COMMENT REVIEW REPORT

CASE NUMBER: C814-89-0003.02

PROJECT NAME: 305 S. Congress

SUBMITTAL DATE: October 12, 2020

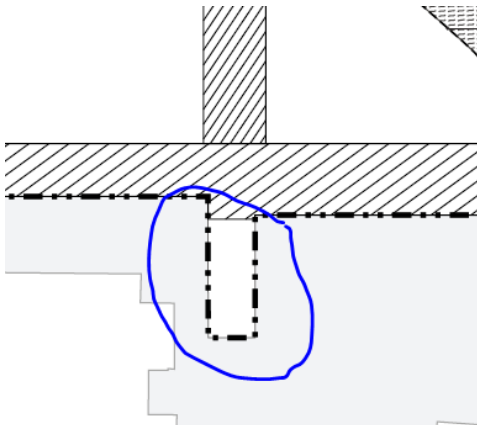
Update 2: Comment pending determination of superiority. Based on the adopted South Central Waterfront Plan, the baseline area of dedication shall be 9.6 acres. Park plan must meet or exceed this benchmark.

- A. Fully dedicated parkland (by deed) is required for the designated park area, and may receive up to 100% credit. Ponds, water quality facilities, floodplain, and inundated land (25 year floodplain) will receive reduced or no credit, consistent with the Parkland Dedication Ordinance. For the next update, prepare a table that shows a breakdown of the various types (e.g. 100 year FP 50%, 25 year 0%, Other encumbered land, generally 50%).**
- B. Other public areas – Plazas and Great Steps, must be recorded as Park Easements and receive partial credit. (This can also ensure that criteria in Parkland Dedication Operating Procedures concerning ROW visibility and access are met).**
- C. Consider inclusion of the area south of the Barton Springs extension as a Parkland Easement, considering this will be part of Crockett Square.**

- D. The Butler Hike and Bike Trail is within a park easement, not yet fully deeded parkland; this area will receive 50% for inclusion within a deed.**
- E. Per the SCW plan, ponds and water quality facilities will exist in parkland. As part of PUD superiority, create a cap on square footage of these facilities in parkland.**
- F. For phasing and triggering of dedication, public access must be granted to the parkland areas as early as possible. The suggestion is to place these in a parkland easement, and dedicate in phases as site plans come in. A Parkland Improvement Agreement (with Programming and Maintenance) will be used to ensure that the parks can be built.**
- G. Consider design modifications to the trail which will achieve superiority for both Watershed and PARD, moving a portion of the trail inland, incorporating rain gardens around the trail, and restoring the shoreline.**

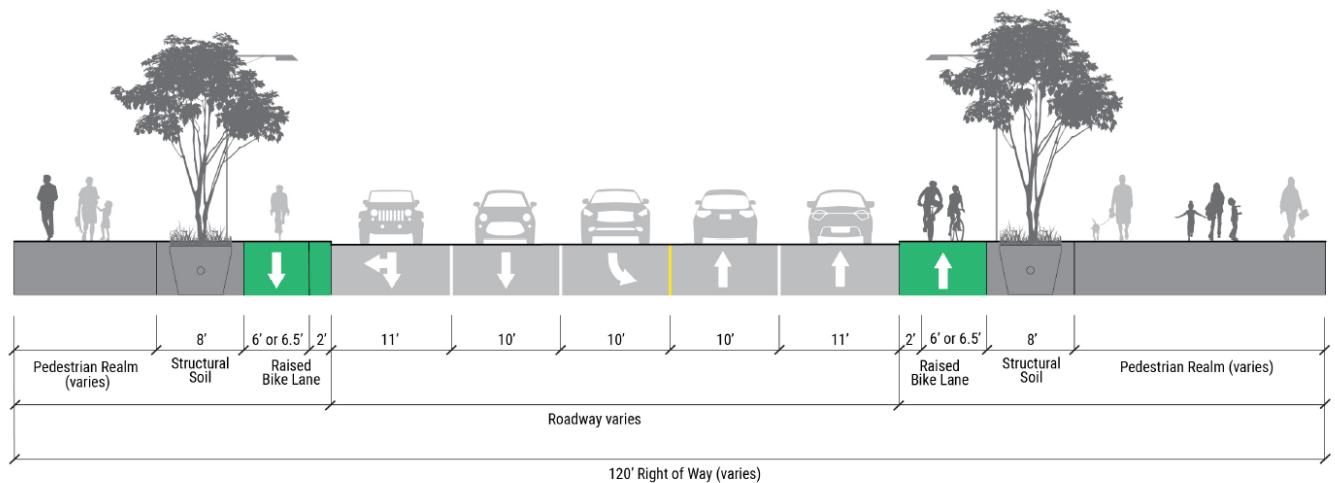
- ATD 5. Street Section A-A: No bike facility is shown in this cross section. The South Central Waterfront plan calls for **a 6'-6.5' raised bike lane behind a 2' buffer** along the east frontage of S. Congress. The ASMP identifies protected bicycle facility along Congress frontage as well. In order to meet the superior results expected from PUDs, the cross sections should at least meet the baseline set by ASMP.

Update 2: The recently installed protected bike lanes must still be included within the cross section. PUD A-A cross section should mirror South Central Waterfront Plan for S. Congress (Core Transit Corridor):

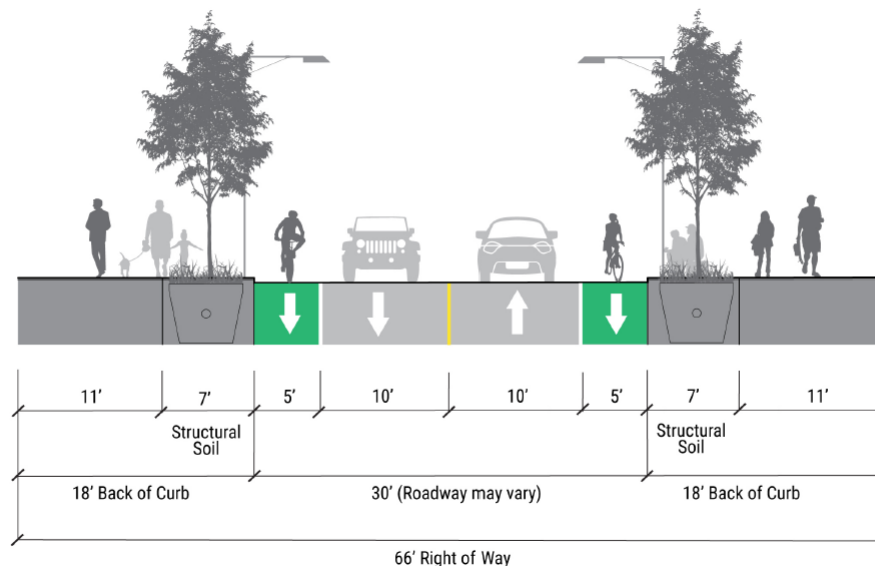
- ATD 6. Street Section C-C: ASMP calls for this to be a 2-lane street with all ages and abilities bike infrastructure. If this is planned to be a street with low volume (less than 3000 ADT), national best practice would make a simple 5' painted bike lane in each direction acceptable for this facility, which would fit within the roadway width indicated in the cross section. If higher vehicular volume is planned, a protected bicycle lane would be necessary to be an all ages and abilities facility.

Update 2: If 5000+ VTD are anticipated, protected bike lanes are required. The South Central Waterfront Plan requires min. 5' bike lanes (see "Local Street" cross section from SCWP below):

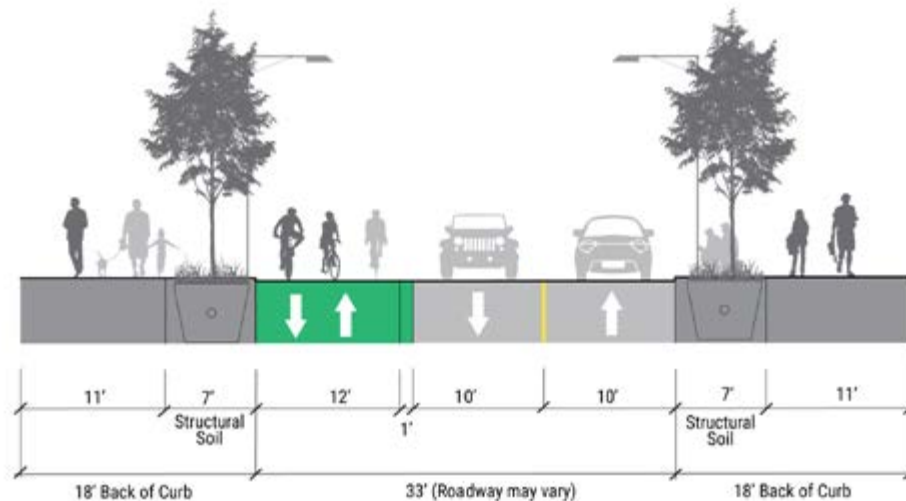
- ATD 7. Street Section D-D: ASMP calls for this to be a 2-lane street with all ages and abilities bike infrastructure. If the space shown in the cross section is intended as a two-way cycle track, it should be shown that way with vertical separation from vehicular travel space. If that is the

case, 10' would be very constrained given the context of a possible future pedestrian bridge. Recommend 12' minimum width plus a barrier.

Update 2: The SCWP identifies a 12' cycle track with 1' buffer as needed for this shared street. Comment pending further internal review.

Collector New - 1

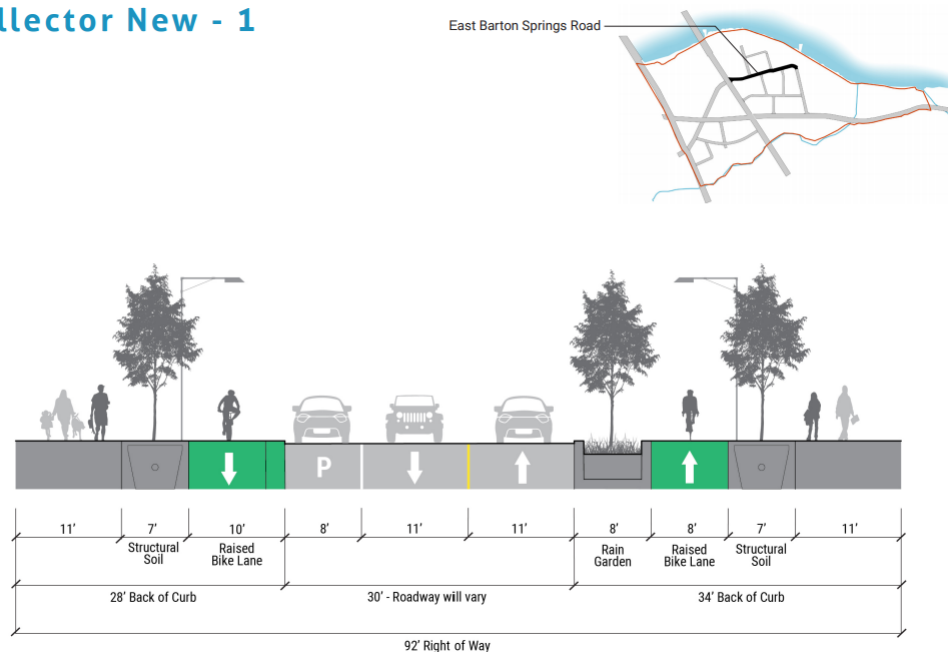
- ATD 10. All new internal roadways, including the extension of Barton Springs Road (requiring 92'), should be publicly dedicated rights-of-way according to the ASMP (detailed in the following chart). Please clarify the following:
- The Barton Springs ROW extension does not meet the ASMP required 92' width or required bike and pedestrian elements of the South Central Waterfront Plan (see below). A "shared lane" is not a bicycle accommodation that ATD approves and separated raised bike lanes are needed.

Update 2: Comment pending TIA and further internal review. At least the northern streetscape (including the 8' min. raised protected bike lane) must be built; this segment is not contingent upon development to the south of this property.

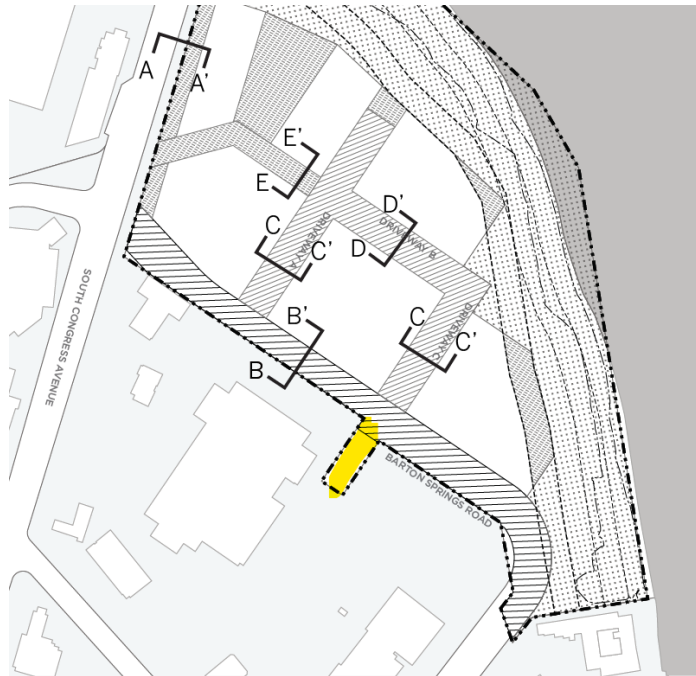
- c. “Driveway C” should extend southward as dedicated right-of-way to allow for future extension, as is required by the ASMP and South Central Waterfront Plan (see relevant highlighted segment below).

Update 2: Comment cleared. Urban Design has indicated that this segment is intended to be dedicated as parkland (“Crockett Square”), per the South Central Waterfront Plan.

Figure 1: SCWP envisioned land-sharing for the Barton Springs East Extension

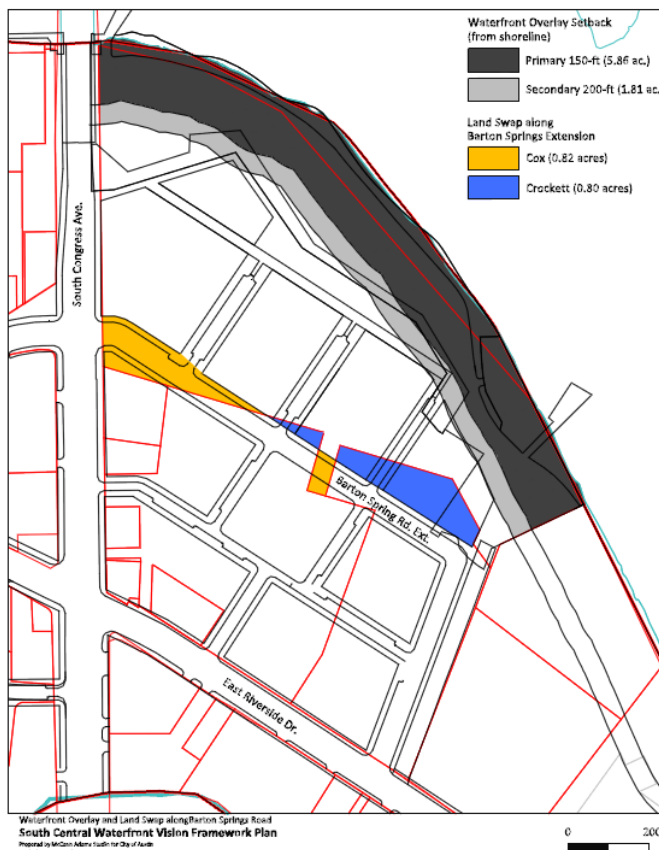
- The SCWP envisioned that the Barton Springs East Extension would place the majority land contribution burden on the Crockett property. According to the SCWP, the 305 S Congress site would contribute 0.82 acres (as shown in Figure 1 in Yellow) towards this street while gaining a roughly equivalent 0.8 acres from the Crockett property (next page, as shown in Figure 1 in Blue) towards the development of the 305 S Congress site., The PUD proposal includes a land contribution (1.61 acres) that would have been otherwise available for development.
 - The SCWP would deem this contribution as a community benefit that should count towards the Applicant's in-kind, on-site community benefit contribution.

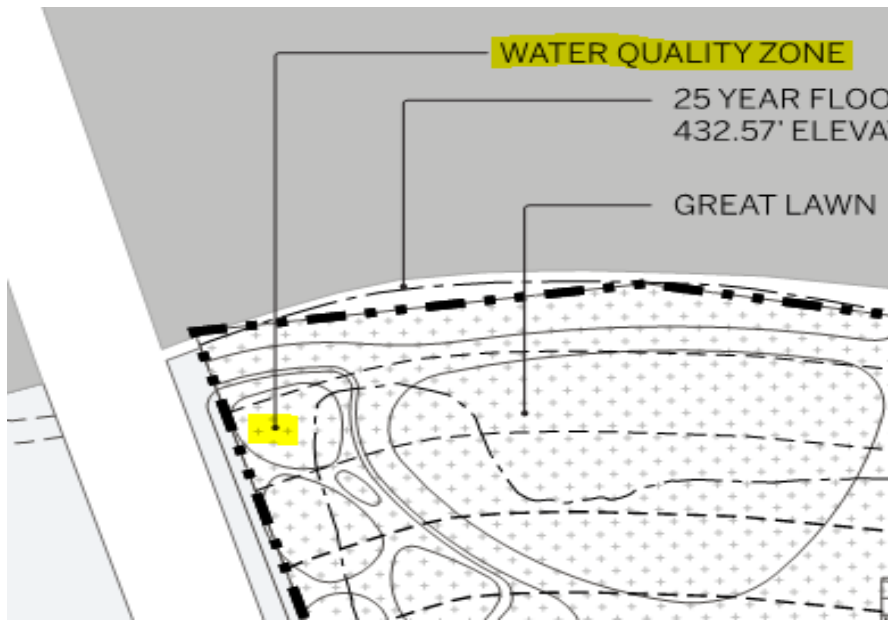
- **Update 2: Comment pending, please see comment above.**
- Clarification of the location, size, and material of all shoreline access structures.
 - Update 1: Comment pending. Land use plan shows 3 potential shoreline access locations for the pier and for both ends of the boardwalk.

- **Update 2: Comment pending. Shoreline access features should be removed from the PUD so that they can be better ascertained when more complete site plan information can be reviewed. Shoreline access is already allowed within the CWQZ but must demonstrate that it is the minimum disturbance necessary.**
